Mr. K. L. Kleinstieber,
Municipal Structural Engineer,
Design Services Branch,
West Bldg., Downsview.

Foundations Office,
Design Services Branch,
Central Bldg., Downsview.

March 20, 1972.

Prescott & Russell Counties, Bridge #28,
Co. Rd. No. 8 Over Bear Brook, W.O. 72-11038,
District No. 9 (Ottawa)

FIGURE 1

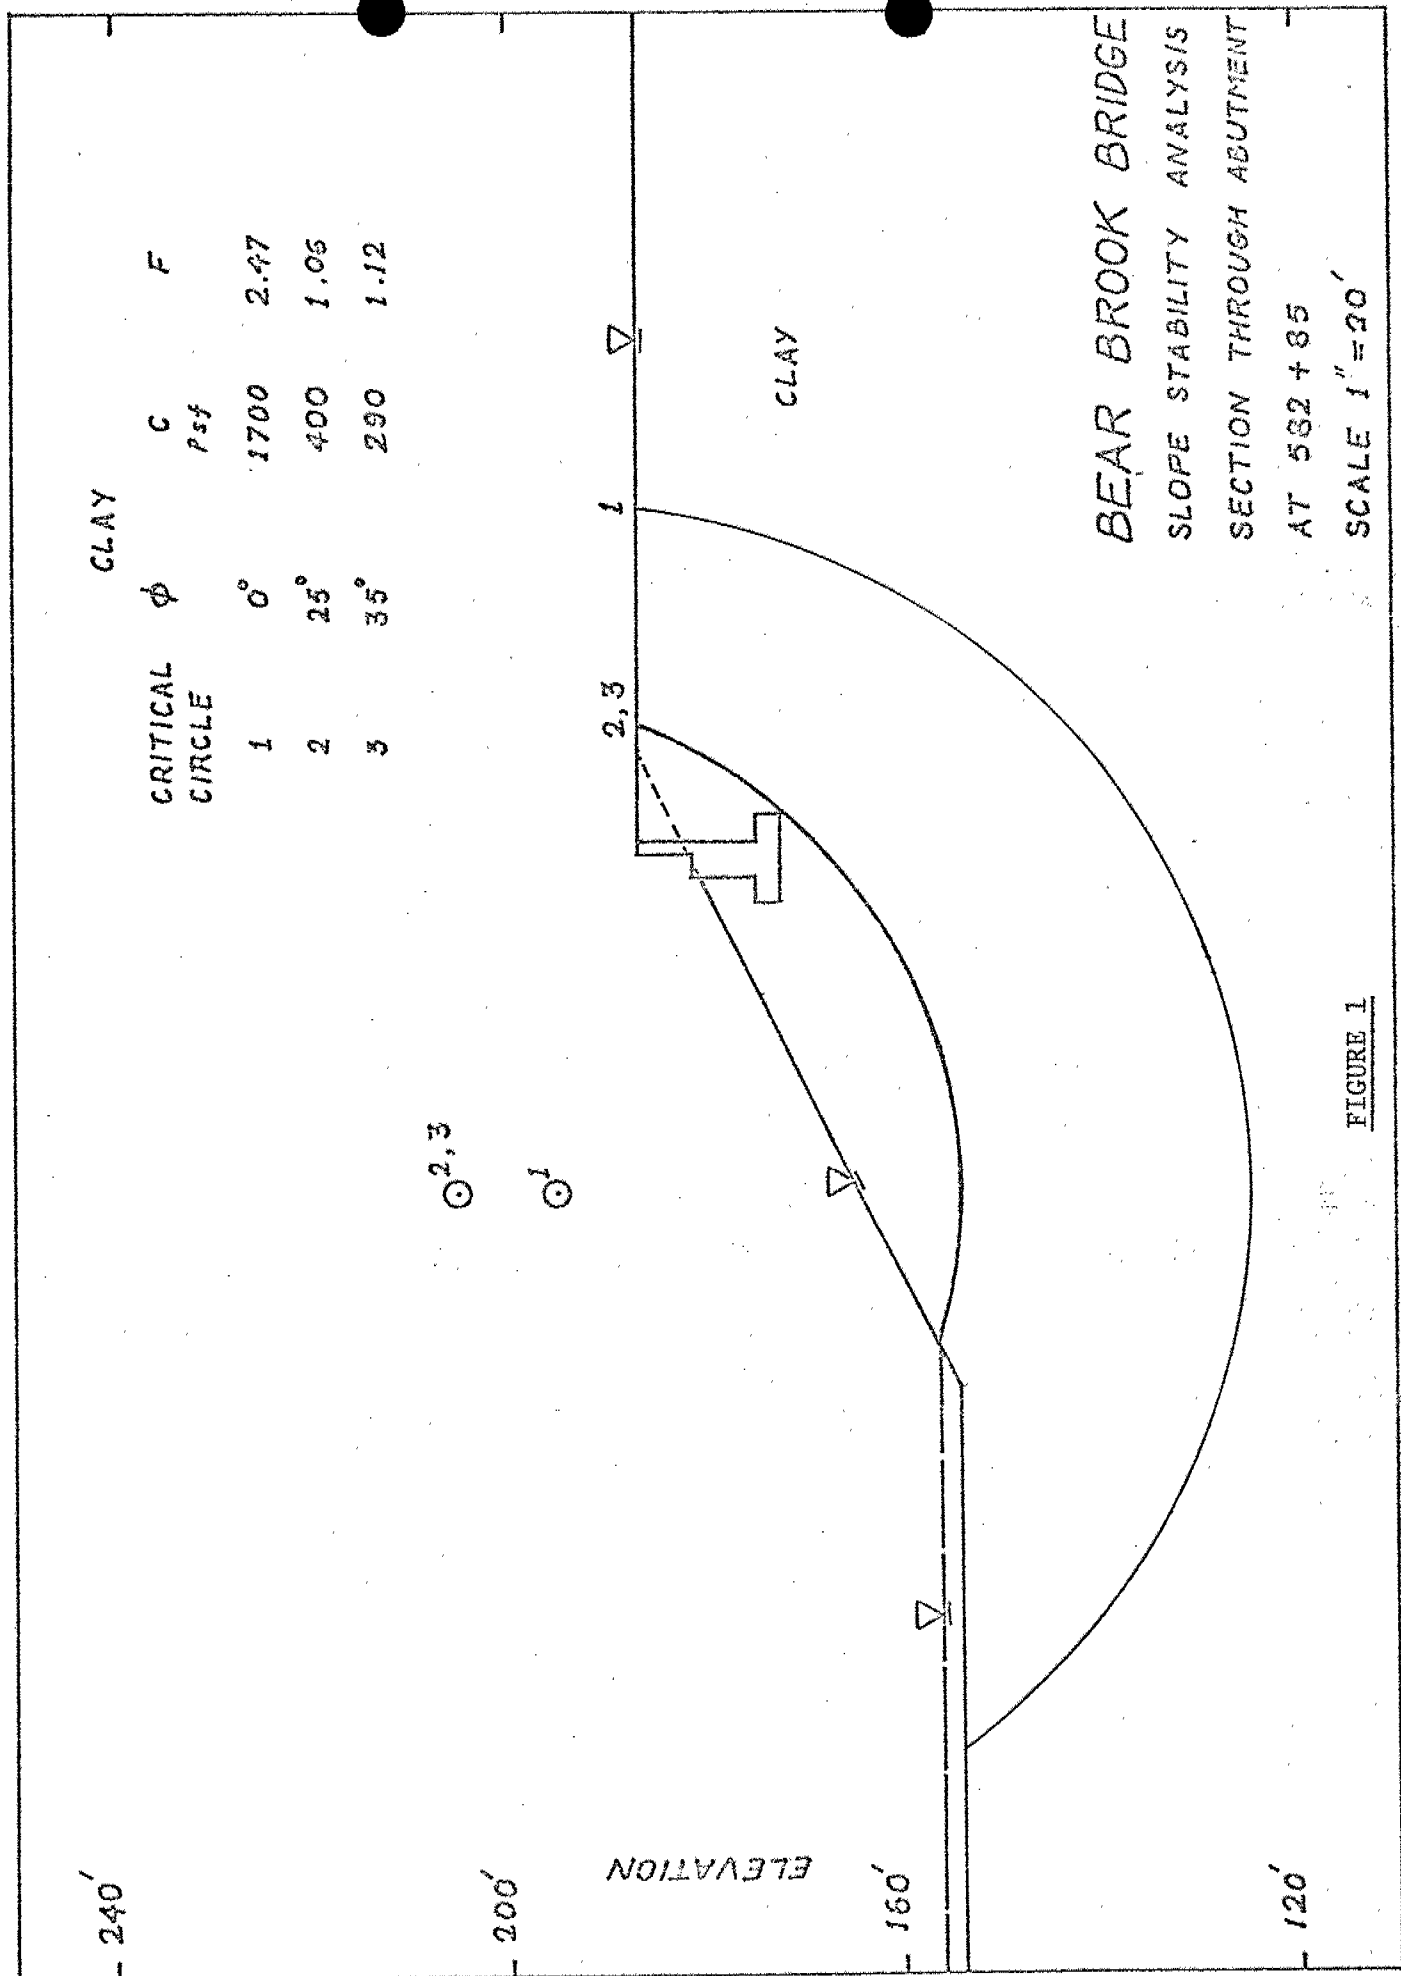
Figure 1 attached shows the factor of safety of the south slope at the bridge site when the full live and dead loads are acting on the abutment and the groundwater table is close to the surface. The factors of safety are given for an undrained shear strength value for the clay of 1700 psf and for a range of effective stress shear strength parameters varying between $\phi' = 25^\circ$, $c' = 400$ psf and $\phi' = 35^\circ$, $c' = 290$ psf.

The factors of safety for the effective stress condition are close to unity and cannot be regarded as sufficient. Figure 2 shows the same conditions but with the ground water table drawn down by drains in the vicinity of the abutment. The factors of safety have increased to 1.2 and 1.3. Although these values would normally be regarded as low, the shear strength values as explained in our original report are conservative and these values for the factor of safety can be considered to be satisfactory.

It is recommended therefore that the south abutment be founded on a spread footing at the shown location with drainage tiles installed both upslope and downslope of the abutment. The drainage system should be designed to prevent freezing and must be able to discharge at all times of the year.

BEAR BROOK BRIDGE

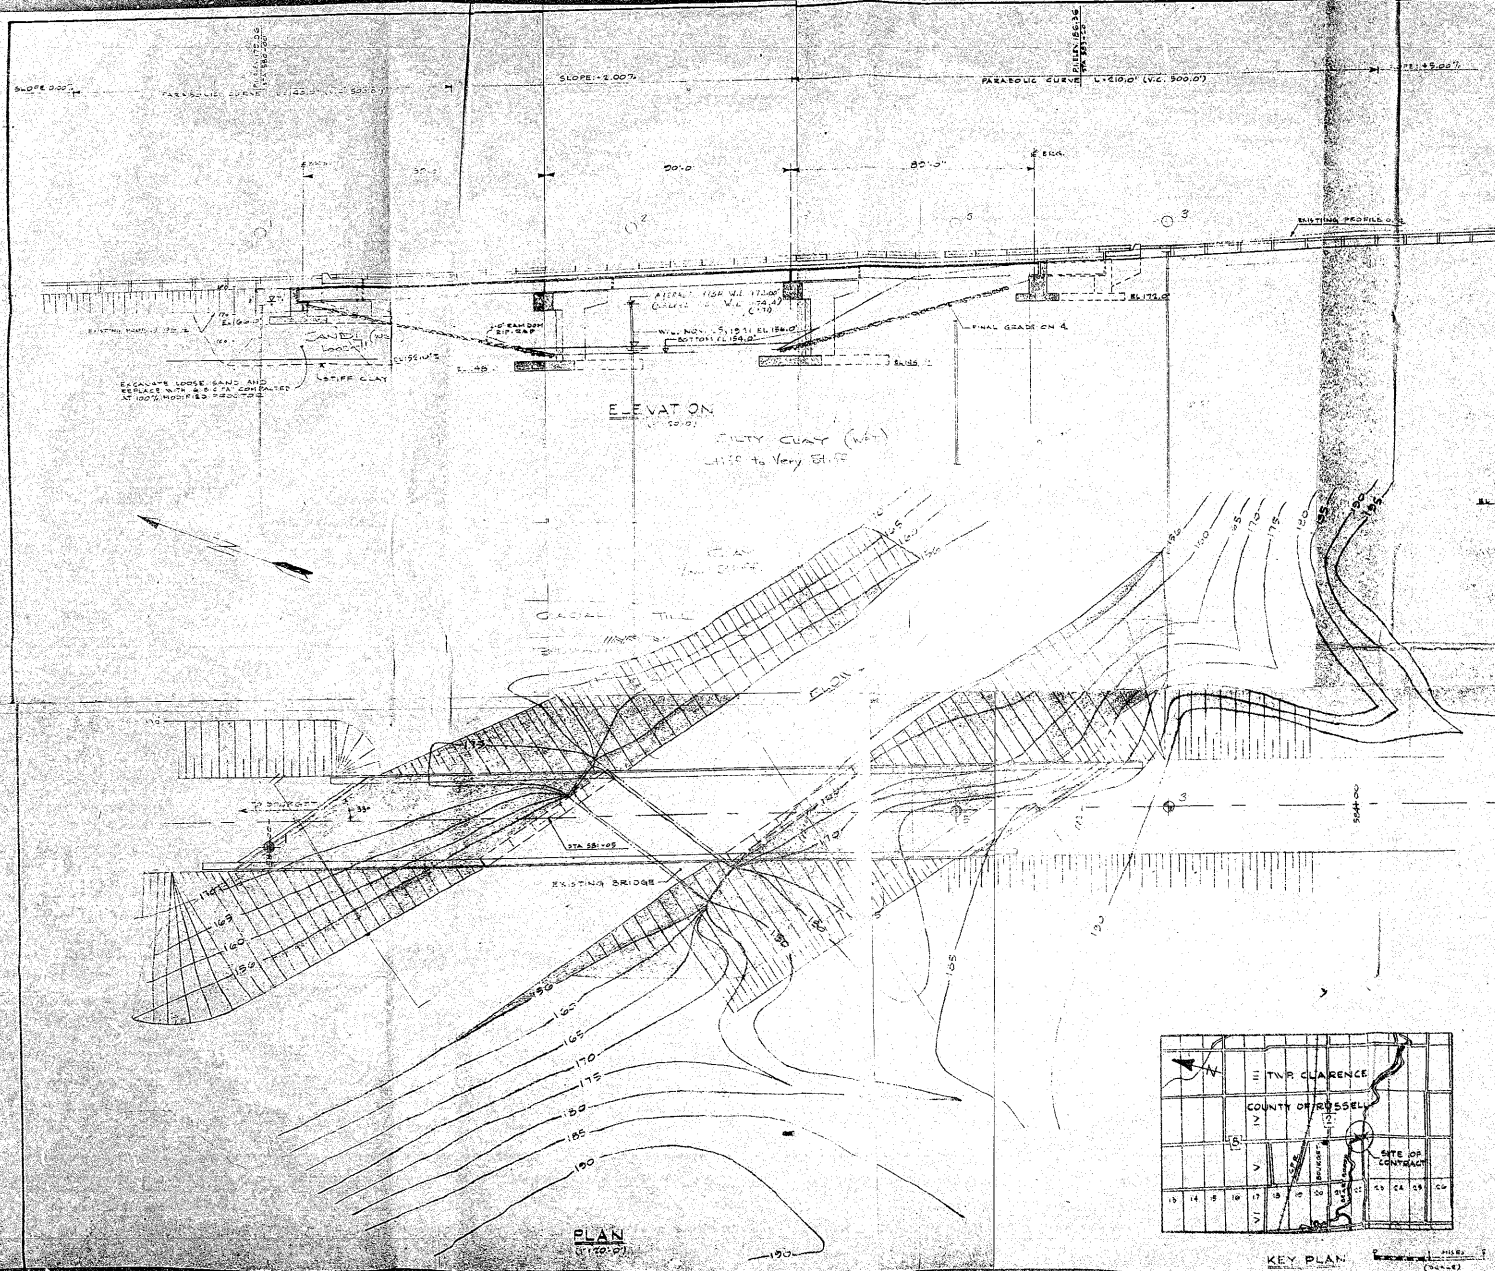
We have reviewed the preliminary bridge plan for the above-mentioned project together with the Foundation Report by Fondex Ltd. During our review we discussed certain matters by phone with Dr. J. D. Scott of Fondex, as a result of which further analyses were carried out. The results of these analyses are contained in a letter by Dr. Scott dated March 8, 1972, a copy of which was also sent to you. We have also consulted Dr. K. Y. Lo of the University of Western Ontario with regard to slope stability in the interim and final conditions and a copy of his report is attached to this memo.

Our comments relating to foundations are as follows:

- 1) In general, the scheme shown on the preliminary plan is acceptable.
- 2) The forward slopes of the structure approaches should be constructed together with the drainage system referred to in Dr. Scott's letter, prior to construction of either the piers or abutments.
- 3) The pier footings should be constructed within a sheeted and braced excavation prior to constructing the abutments.
- 4) The bridge plan does not indicate that flattening of existing slopes as recommended in 10.7, page 31 of the Foundation Report will be carried out. We assume that this recommendation will be followed.
